Addendum No. 1

RE: Contract # C205032

Chatham County (R-5963A)

SR-2700 (CHATHAM PARK WAY) FROM US-15/US-501 SOUTH OF
PITTSBORO TO US-64 BUSINESS.

| REVISIONS | | | | | | SHEET NO. W-7 |

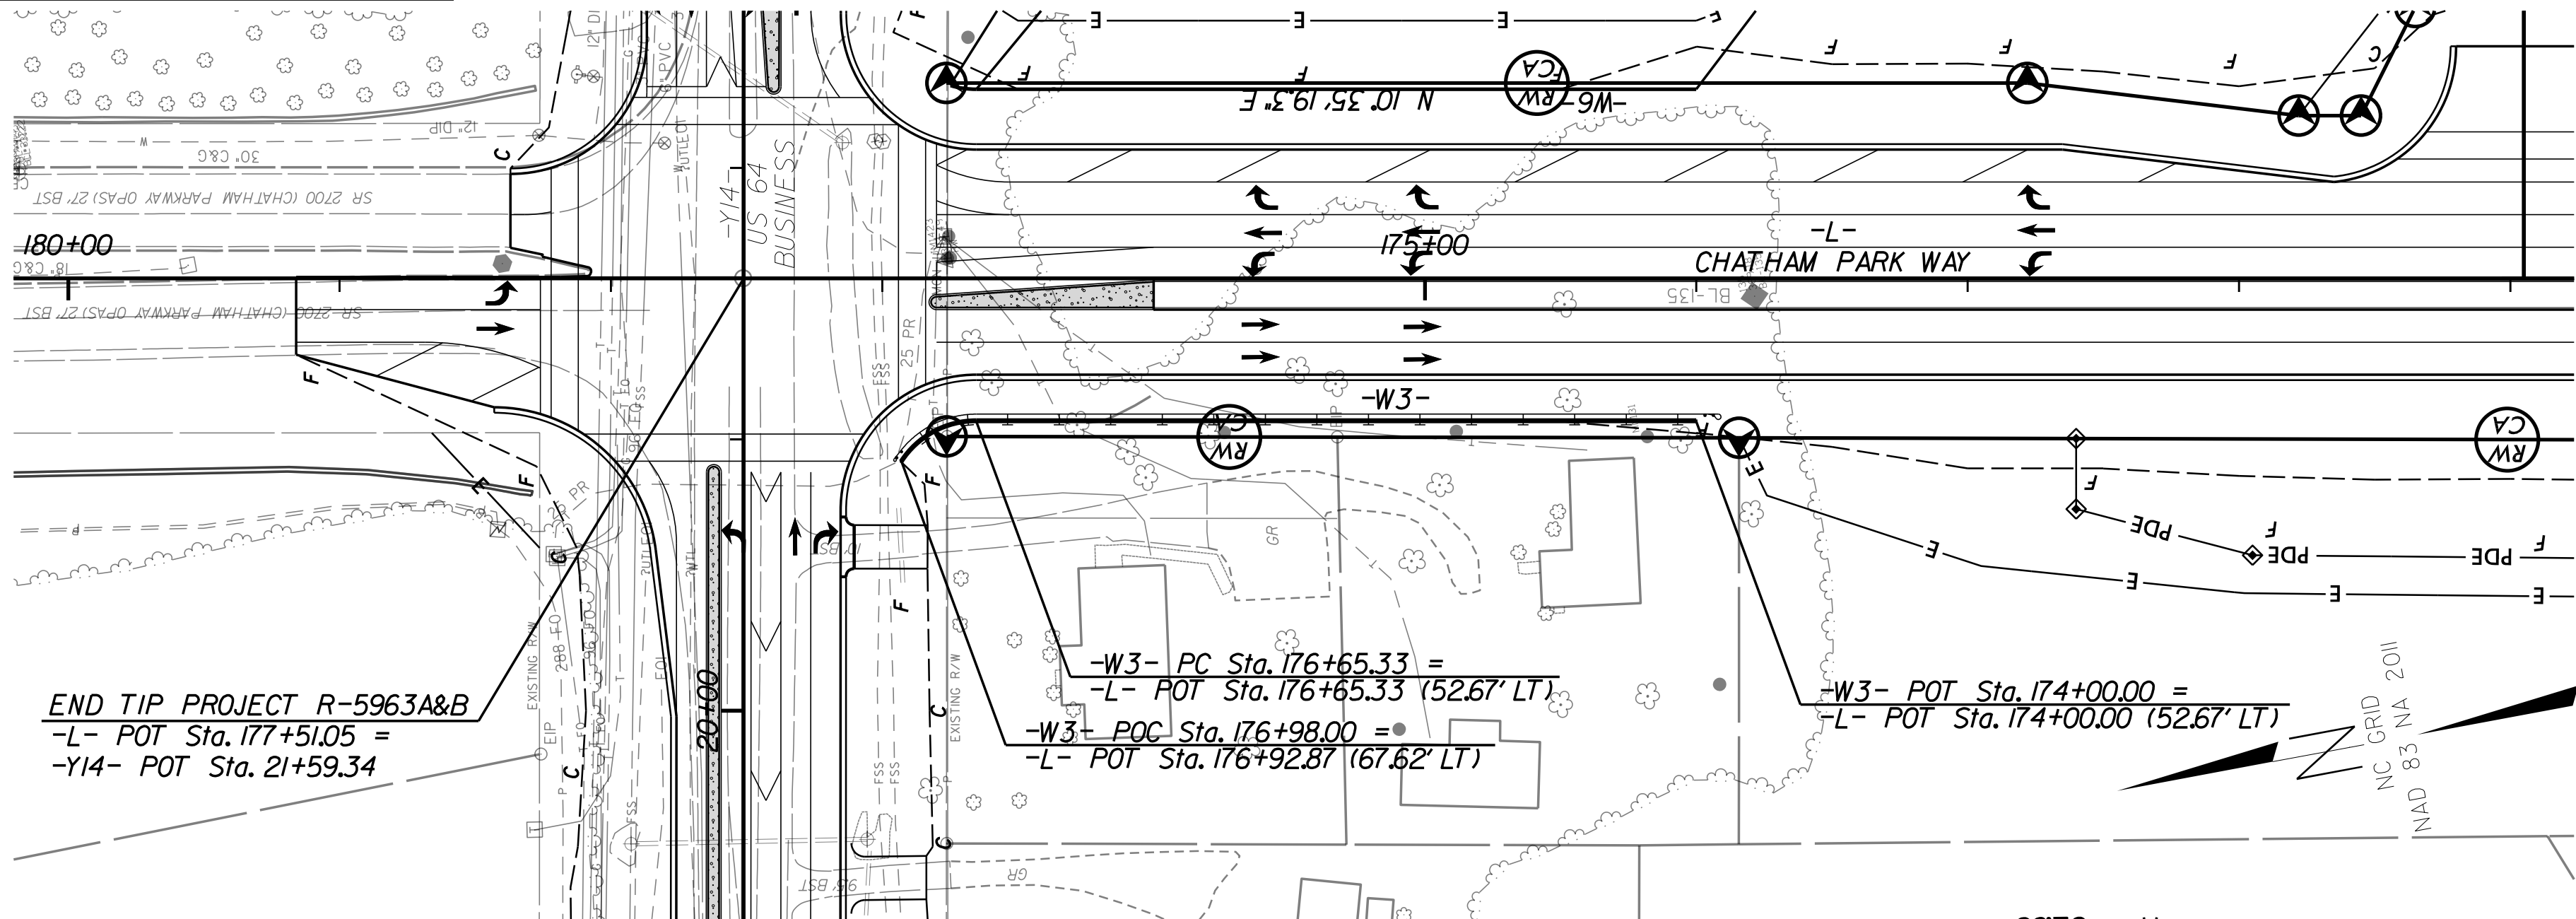
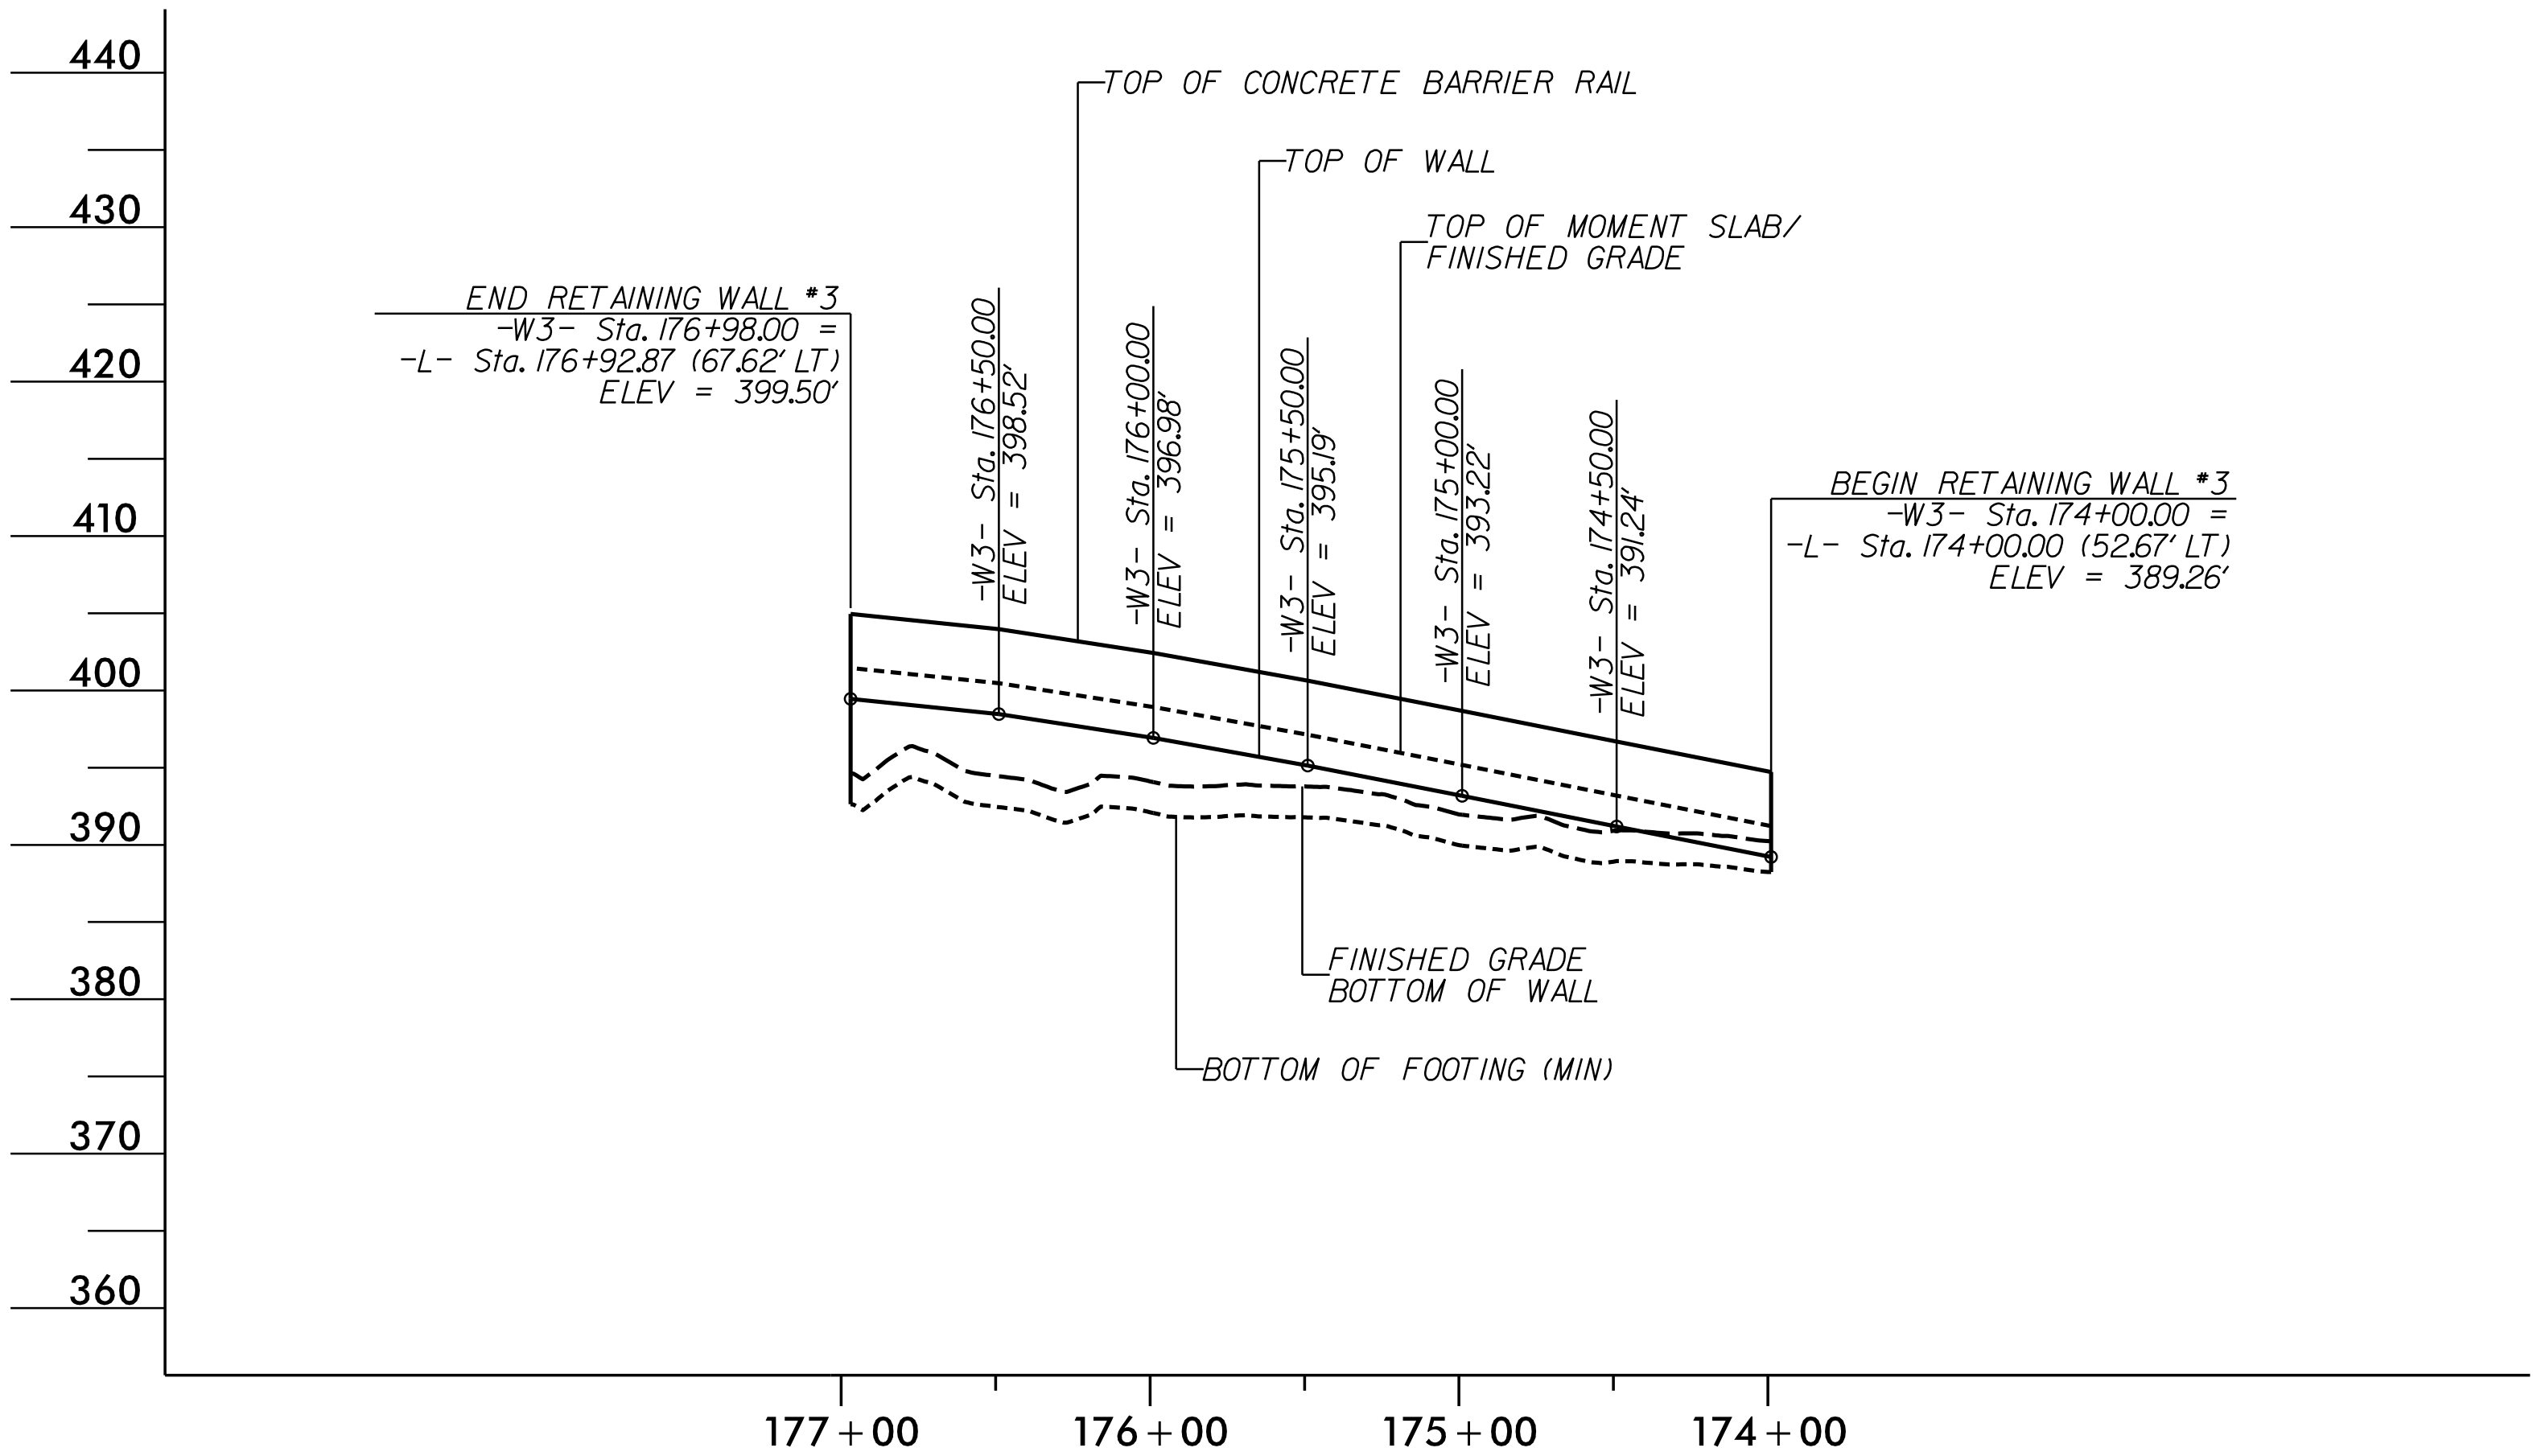
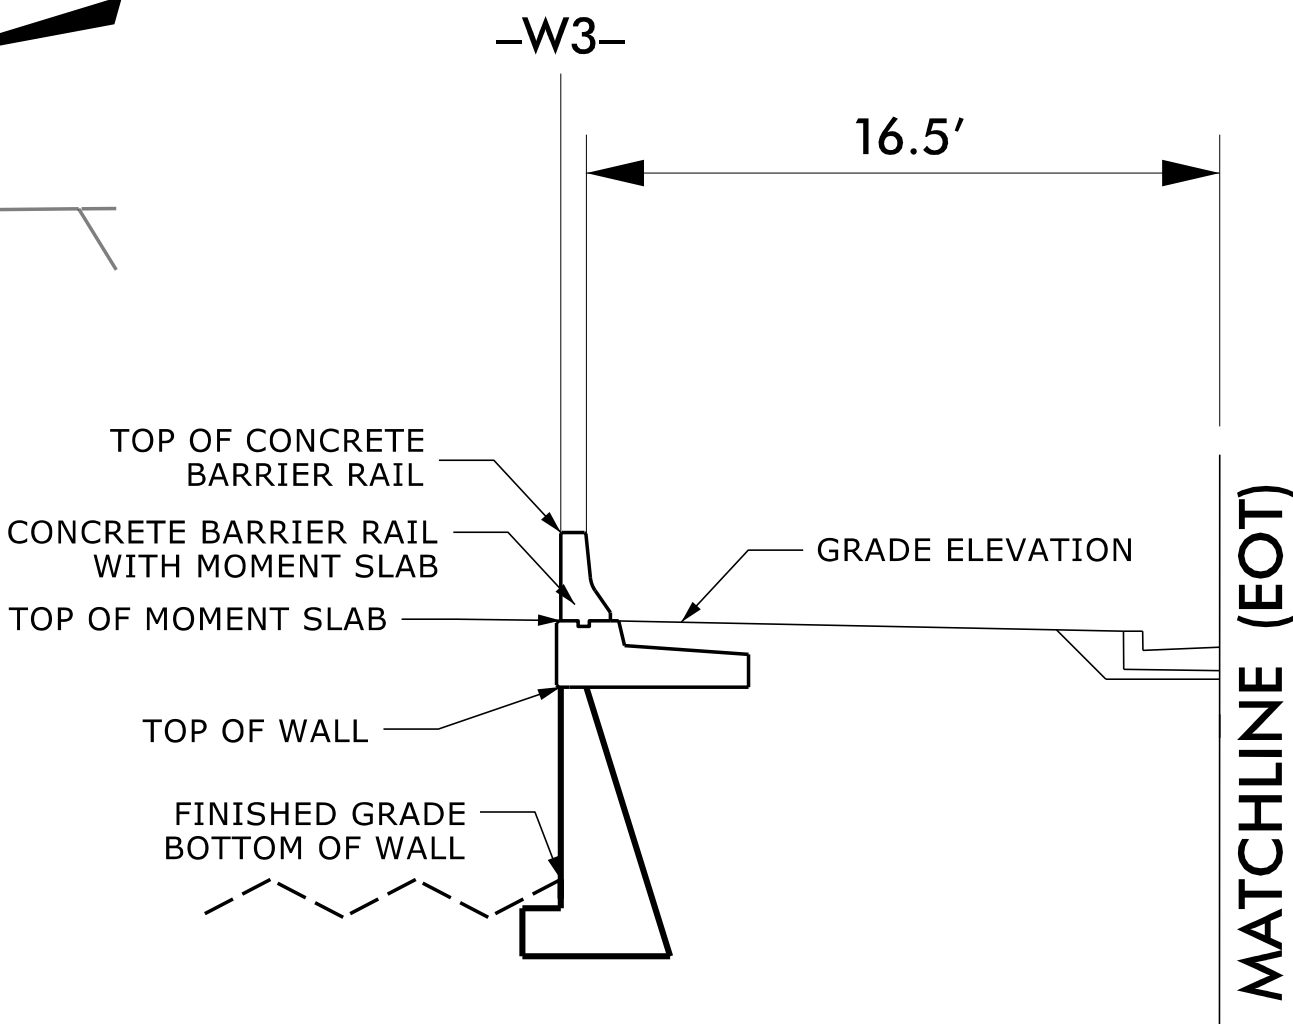
| Sheet No. | Revision |
|--------------|--|
| W-7 | Retaining Wall #3 – Envelope replaced with wall envelope provided 5/8/25. Revised callouts: Top of Concrete Barrier Rail, Top of Moment Slab/Finished Grade, Finished Grade Bottom of Wall (replaced Ground Elevation/Bottom of Wall). |

| Sheet No. | Revision |
|--------------|--|
| W-7 | Revised -W3- Typical Section. Added callouts: Top of Concrete Barrier Rail, Top of Moment Slab, Top of Wall, Finished Grade Bottom of Wall, Updated the Alignment to -W3- (replaced -W5-) |
| W-7 | Revised CIP Concrete Retaining Wall quantity to reflect provided profile and added Simulated Stone Form Liner quantity. |

| REVISIONS | | | | | | SHEET NO. W-8 |

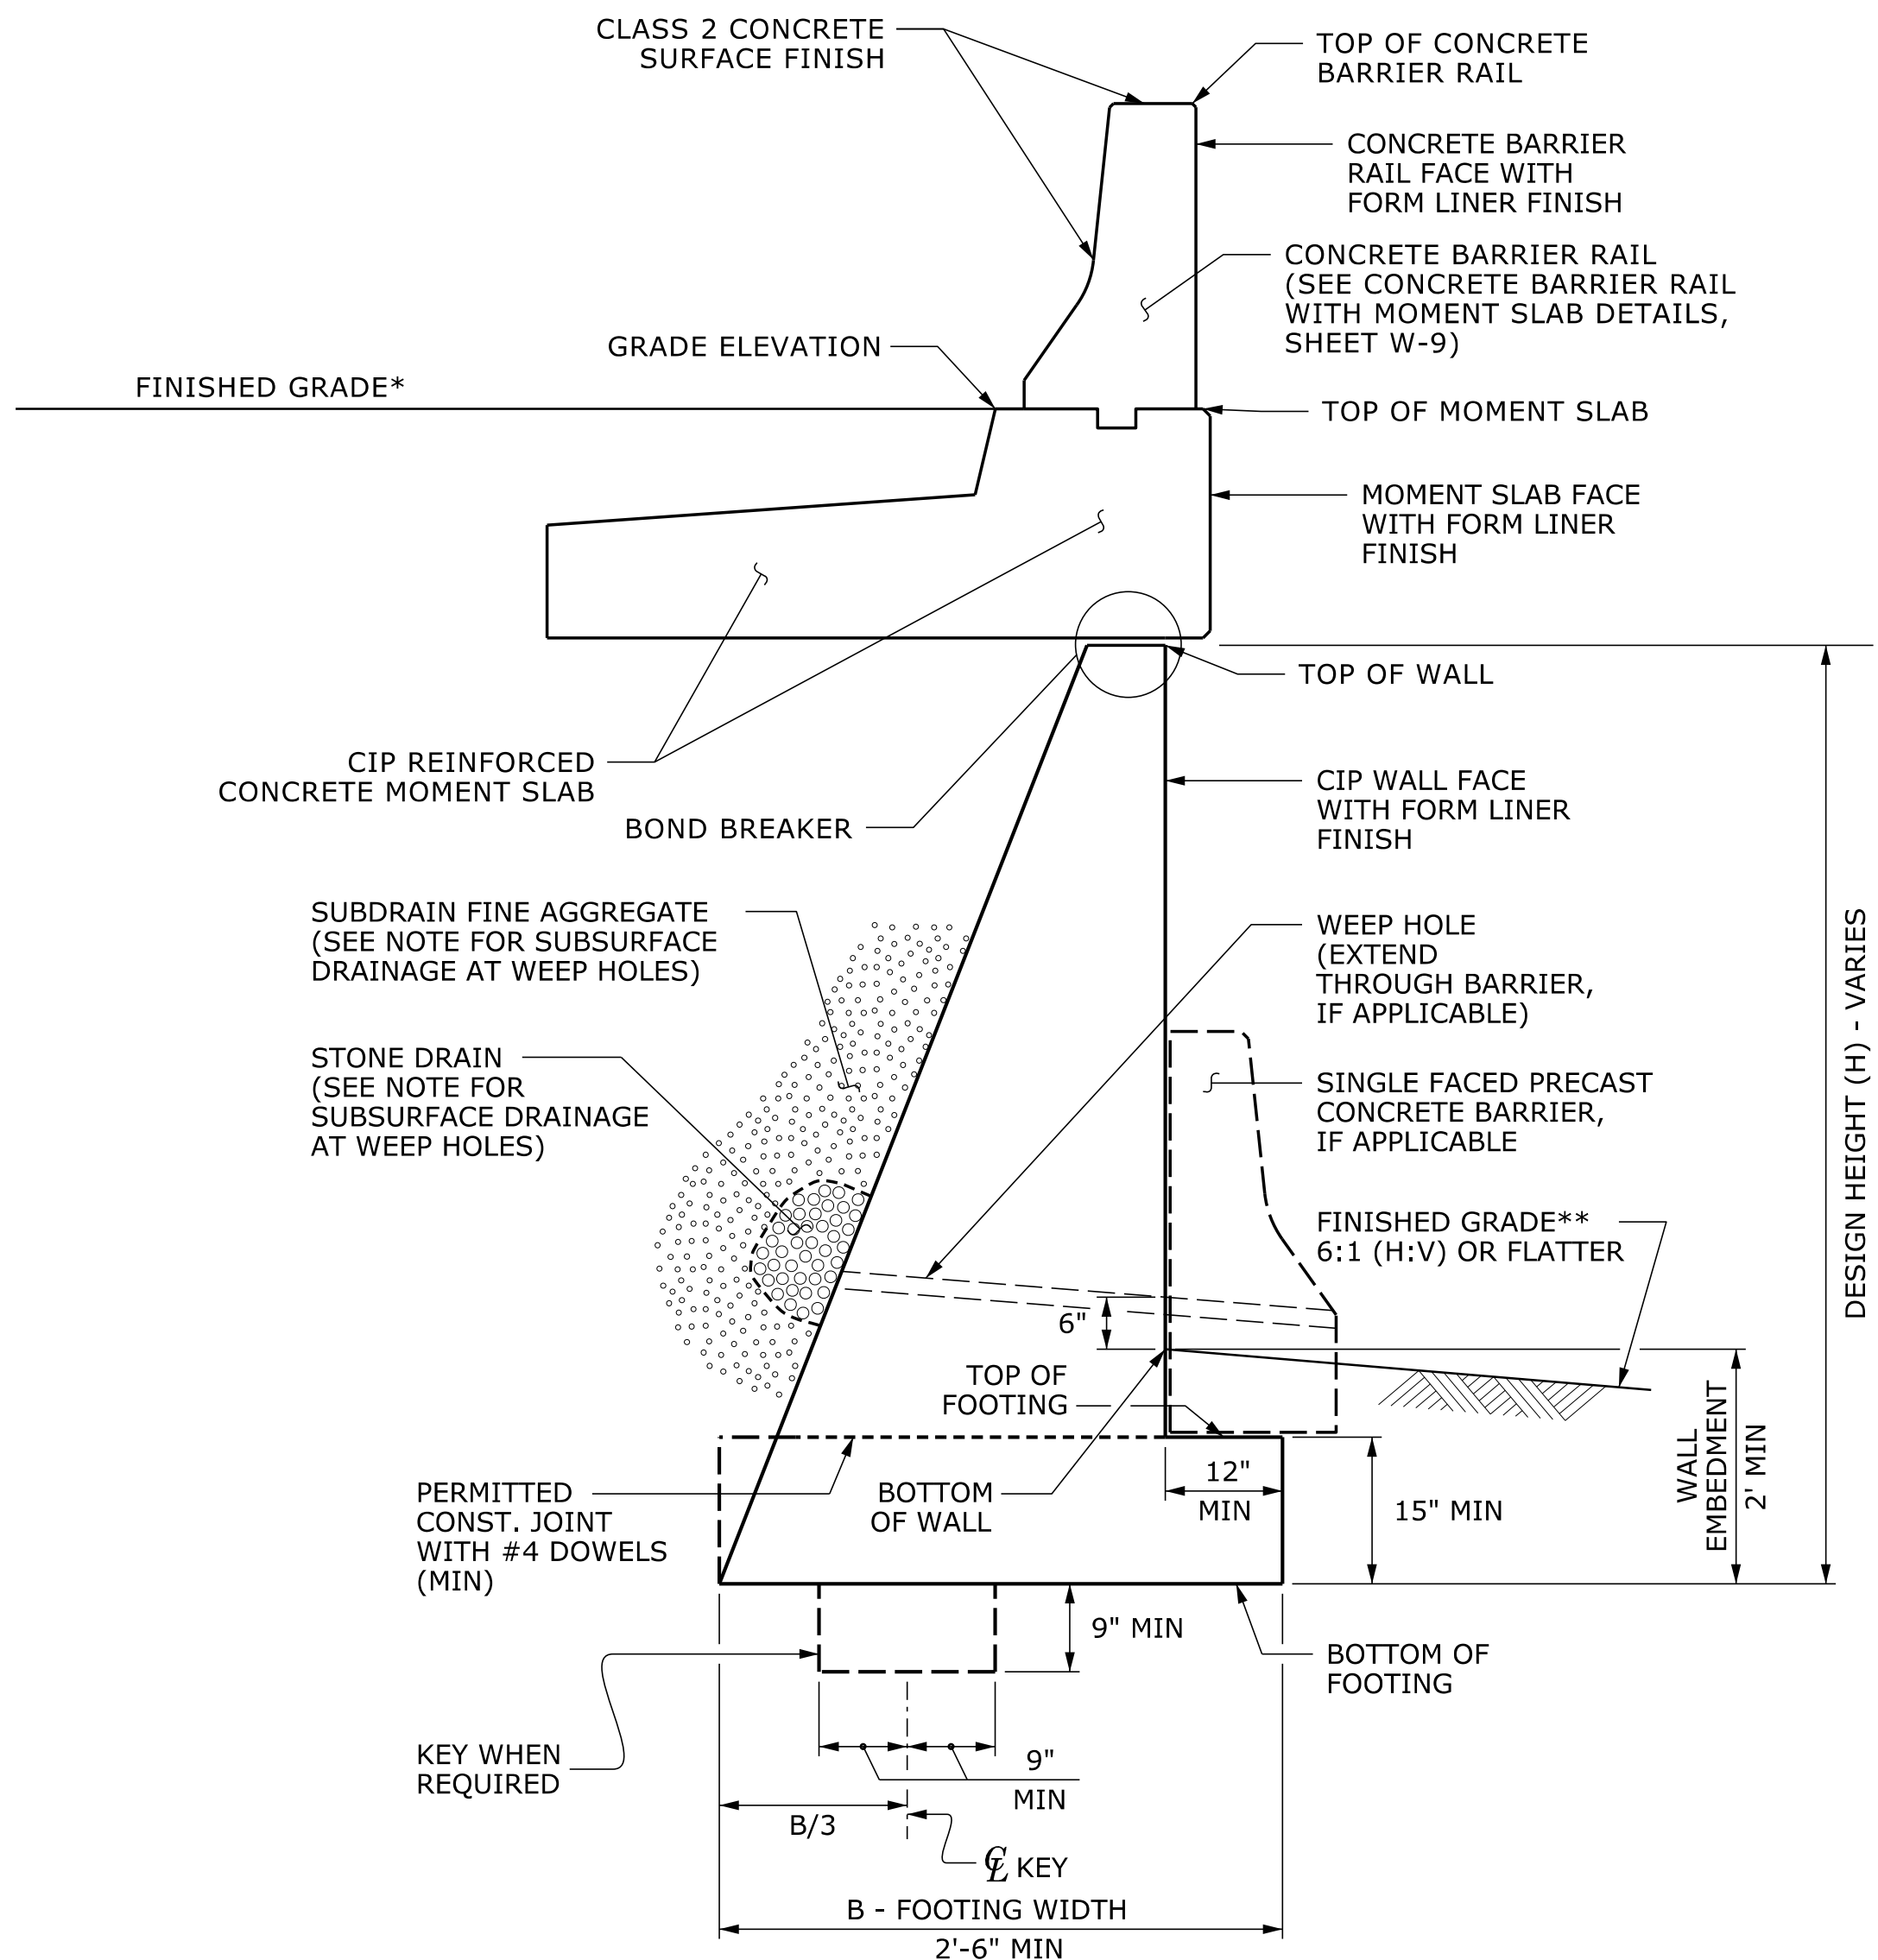
| Sheet No. | Revision |
|--------------|--|
| W-8 | Revised Non-Standard CIP Gravity Wall detail. Added callouts for the following: Class 2 Concrete Surface Finish, Top of Concrete Barrier Rail, Concrete Barrier Rail Face with Form Liner Finish, Top of Moment Slab, Moment Slab Face with Form Liner Finish, Bond Breaker (and shifted moment slab and barrier up to show gap for the bond breaker callout), CIP Wall Face with Form Liner Finish (Replaced Wall Face callout) |
| W-8 | Added the last 3 notes. |
